This letter is to request a review of several changes planed to the Metorex SIPS probe which is currently covered by Registry NR-0701-D-104-B. These modifications are in the latter stages of design and evaluation but have not yet been formalized. These changes will be implemented in the fall of 1999 and will occur in all probes. Thus, these modified probes will be identified by a serial number greater than a certain number that will be determined at a later date.

Modifications to SIPS Probe NR-0701-D-104-B

The configuration of the detector in the SIPS probe has been changed to achieve better analytical performance. In conjunction with this change a few changes have been made to the mechanical parts of the probe.

Attachment 1A

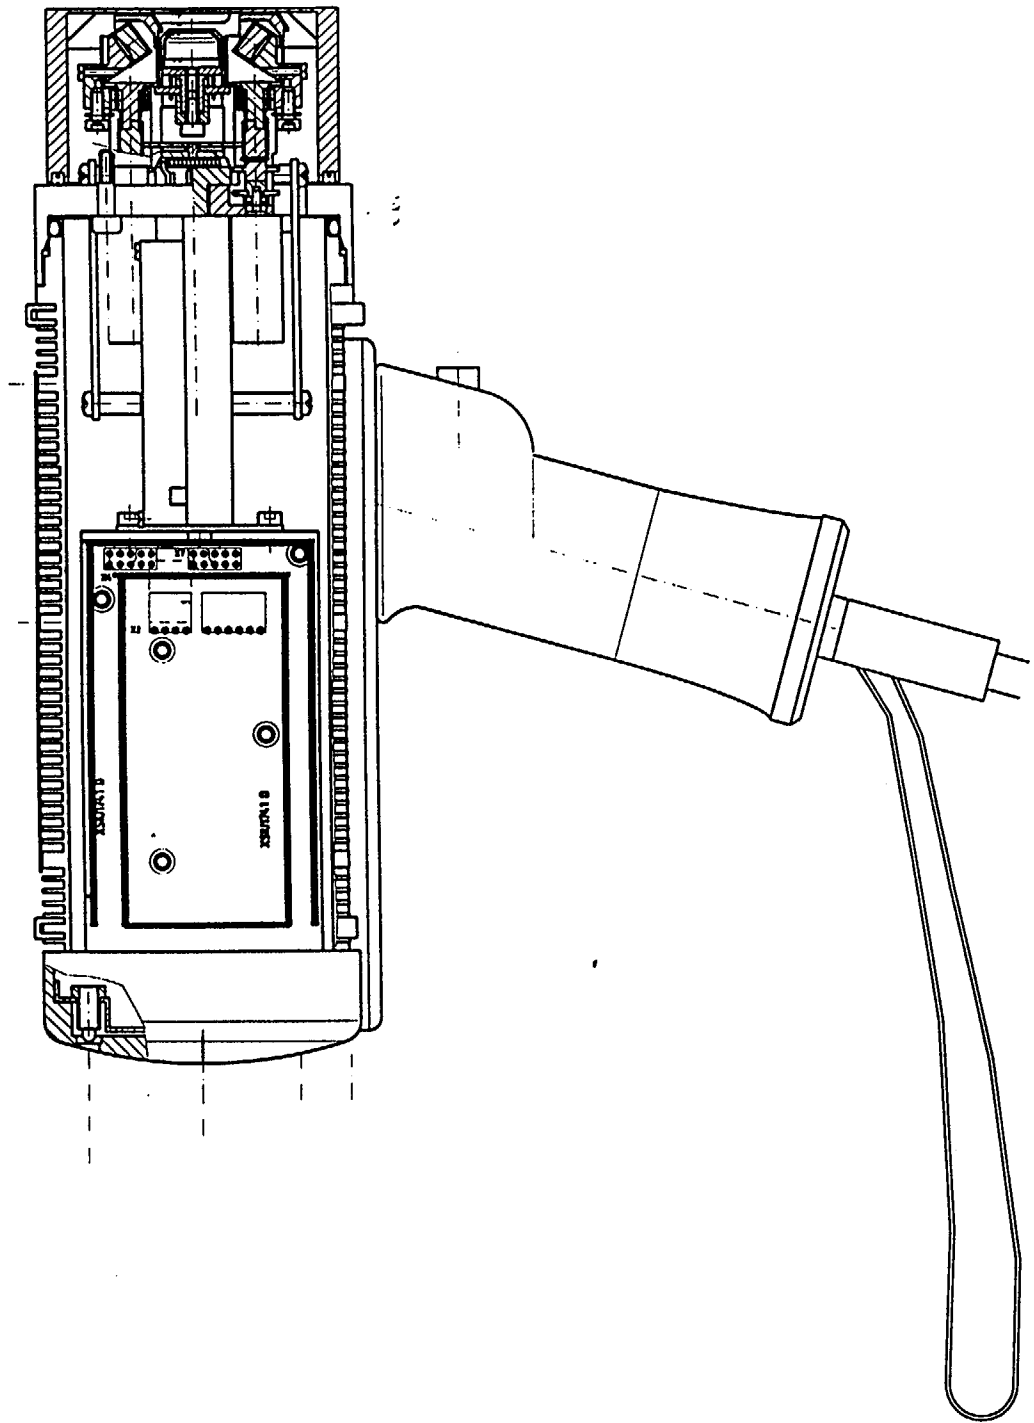
Attachment 1A (p3) is a drawing of the redesigned probe. Two external modifications have been made to the probe. First, three of the groves in the body of the probe have been eliminated. This provides a more secure mounting for the screws that hold the radiation warning label. The second change is that a new handle has been designed which better fits the grip and includes a safety strap to minimize the chance of dropping the probe. In addition, the probe cable now enters the probe through a connector rather than being hard wired to the probe.

Attachment 2A

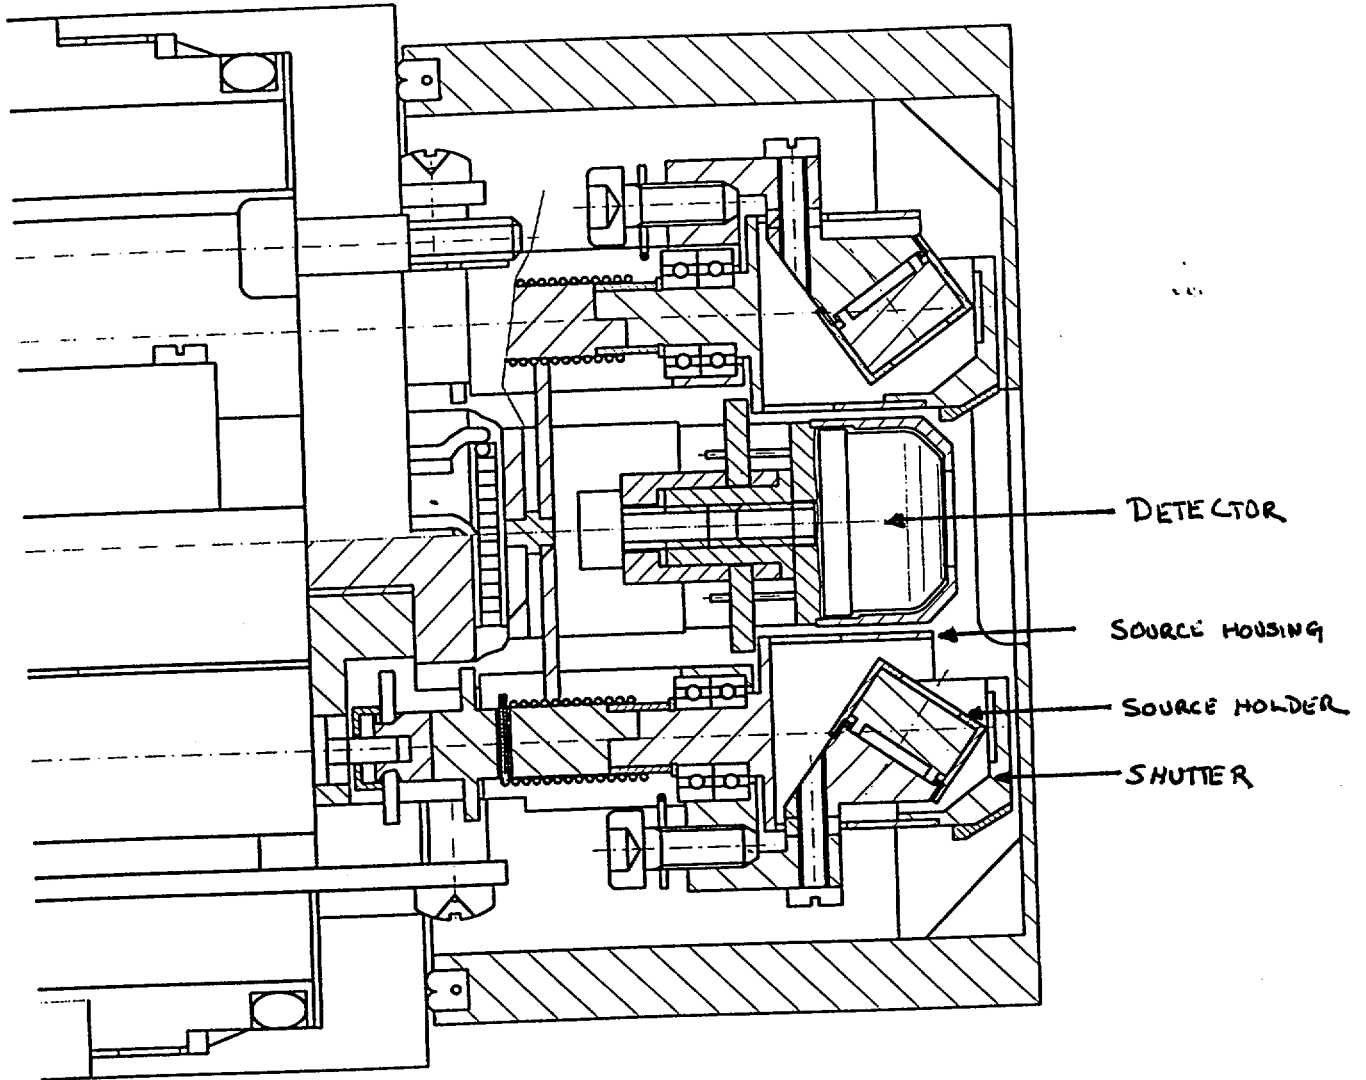
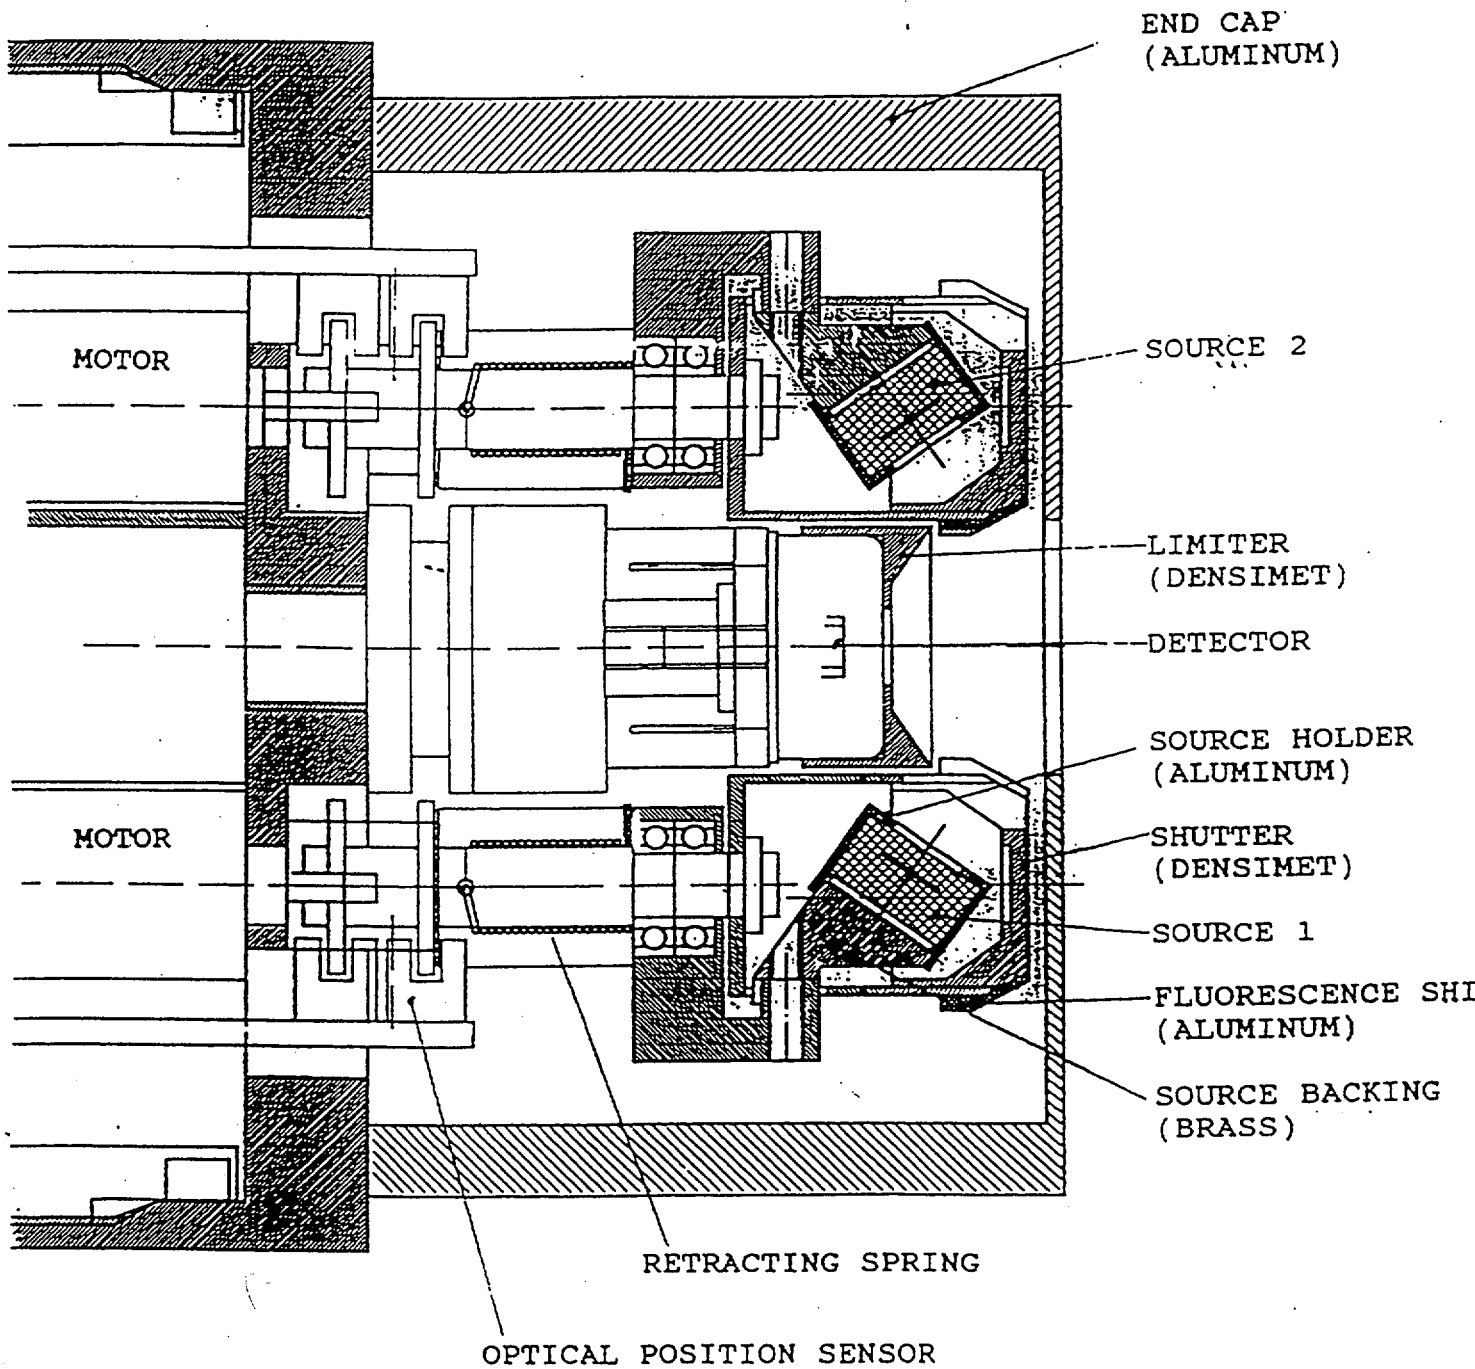
Attachment 2A (p4) shows the modification of the detector geometry. In this view, the lower shutter is opened and the upper shutter is closed. When compared to Attachment 2 (p5) from the registry, the change in the position of the detector can be seen. The detector is much closer to the front of the probe. In order to shield the detector from the source, the source housing has been modified slightly (p6). Thus, the shutter opening is slightly smaller than in the original probe. Otherwise, no changes have been made to the source holder and/or the shutter mechanism.

ATTACHMENT 2

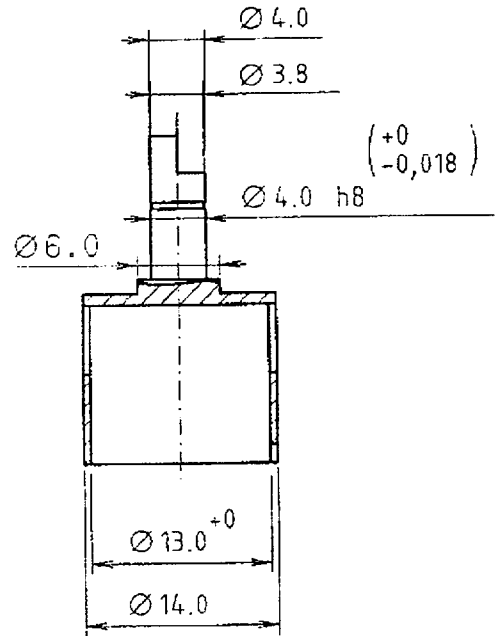
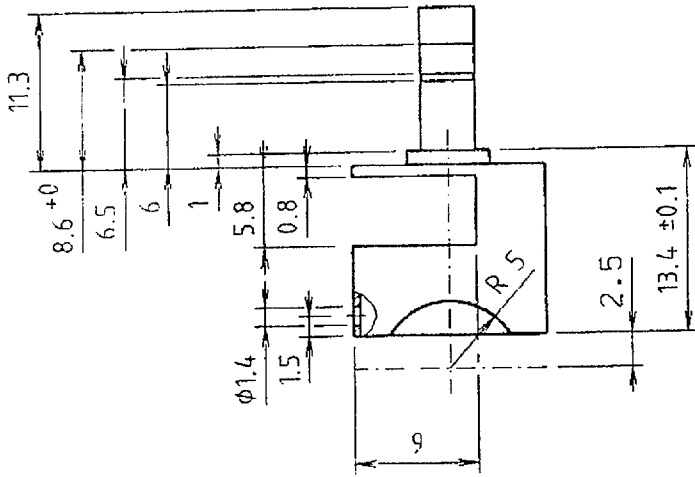
This machining is left away from the new SIPS.

Attachment 3A

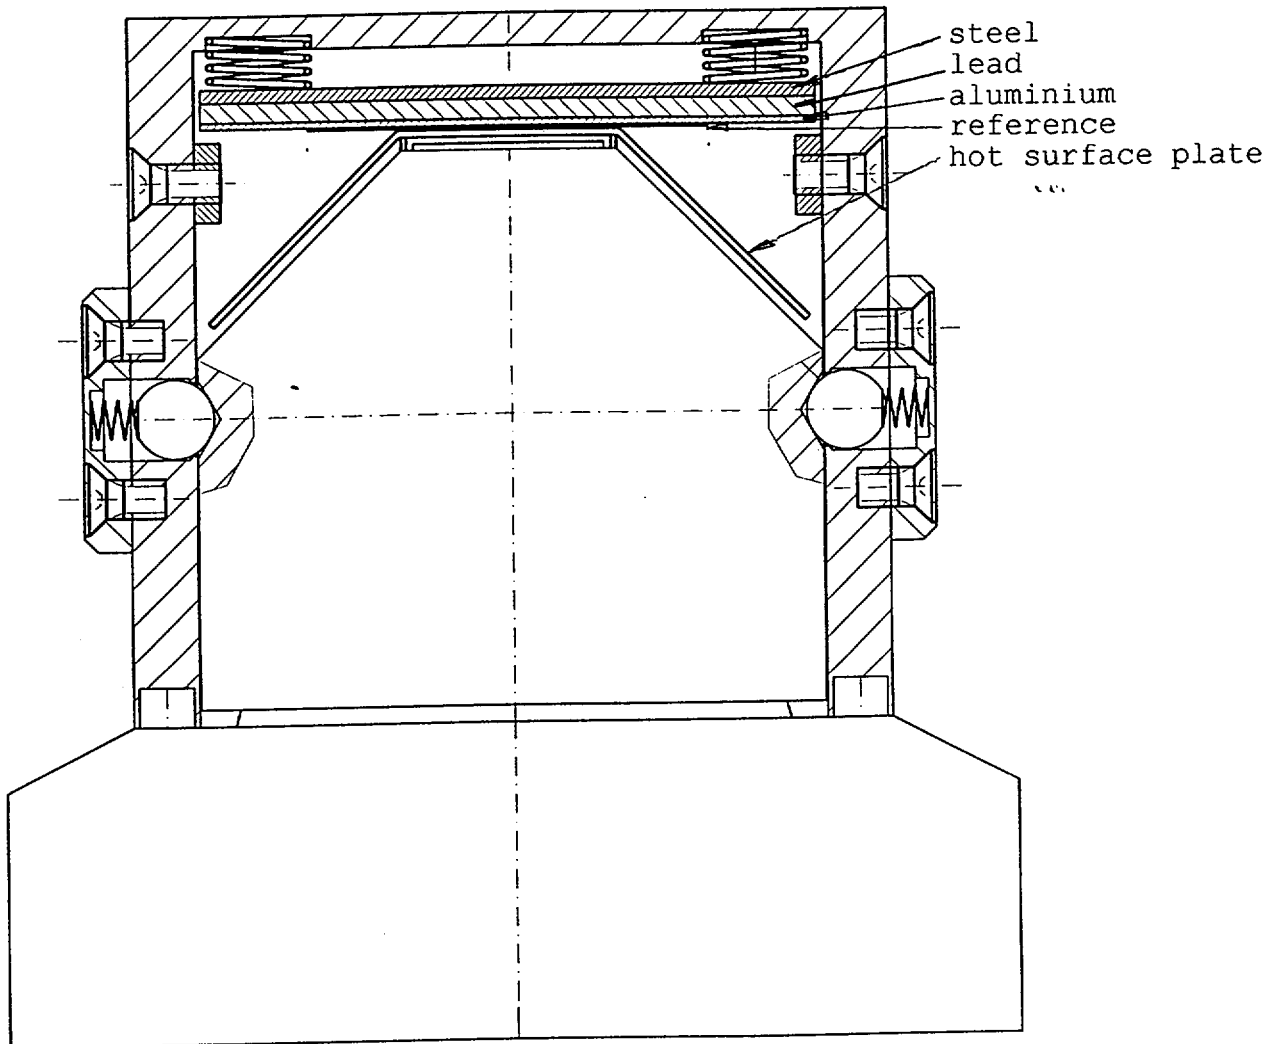
Attachment 3A (p7) illustrates the new heat shield and end cover. The heat shield (Attachment 4; p8) is an option for the unit to allow the probe to be used at elevated temperatures. The shield and associated mounting slightly separate the probe from the sample and provide some insulation. The installation of the heat shield slightly extends the length of the probe snout. Thus, with and without the shield, the probe snout will be of different lengths. This has led to the development of a new end cover. In this version, the cover is fixed onto the probe snout with two spring loaded balls in the side of the cover. These balls fit into the small conical recesses in the probe snout. The cover is slightly longer than the old version and shielding mechanism is floating on four (4) springs. Two (2) bars on the side of the cover limit the outward movement. The same cover is used with or without the heat shield. The shielding mechanism is sandwich composed of a lead sheet between a steel and aluminum sheet. A copper reference sample is attached to the front of the sandwich. The steel plate adds to the shielding provided by the cover when compared with the previous cover.

Heat cover

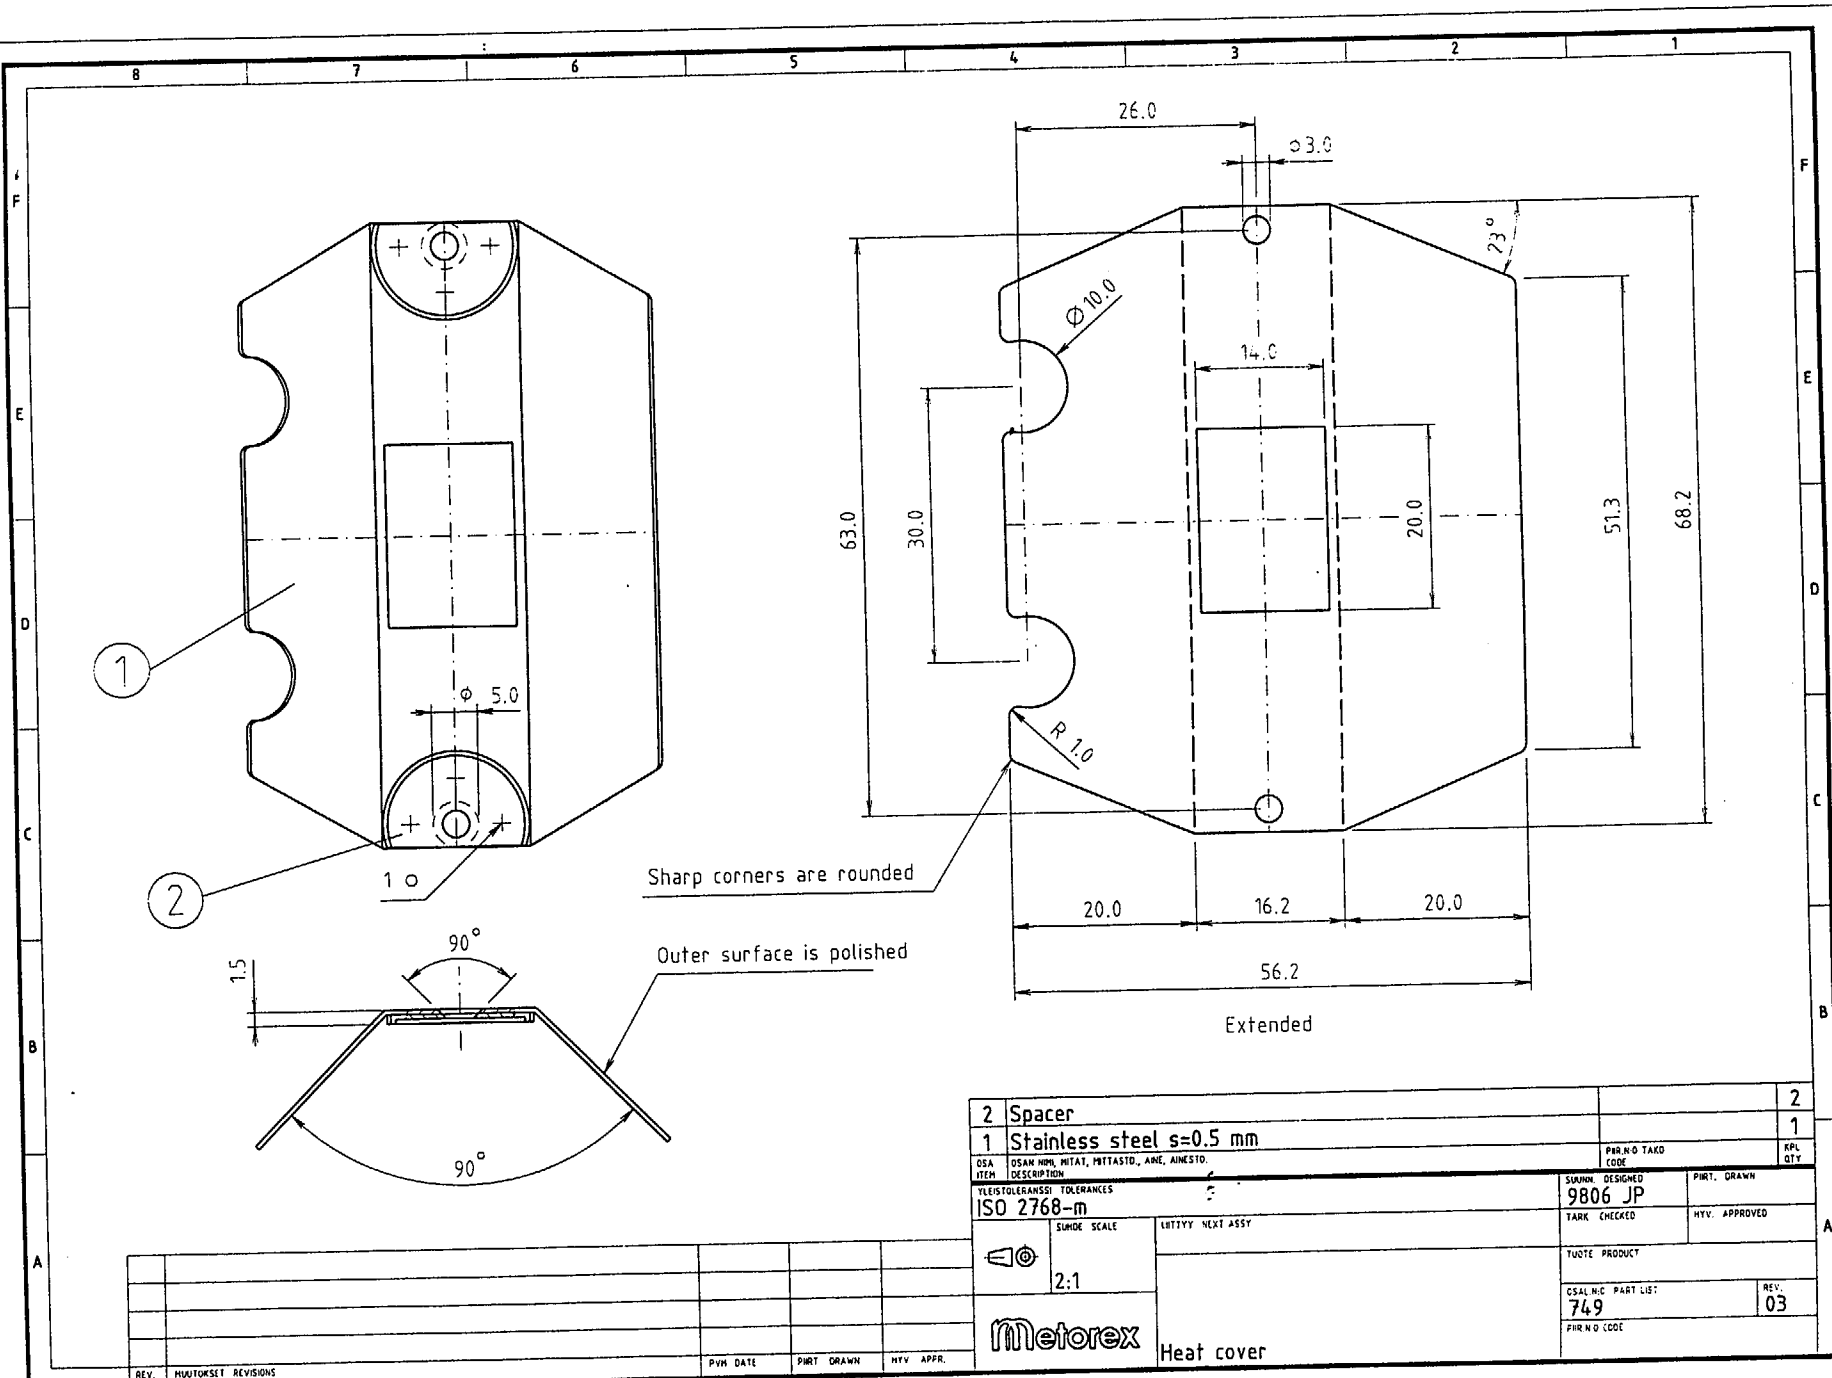
Sharp corners are rounded

Outer surface is polished

Extended
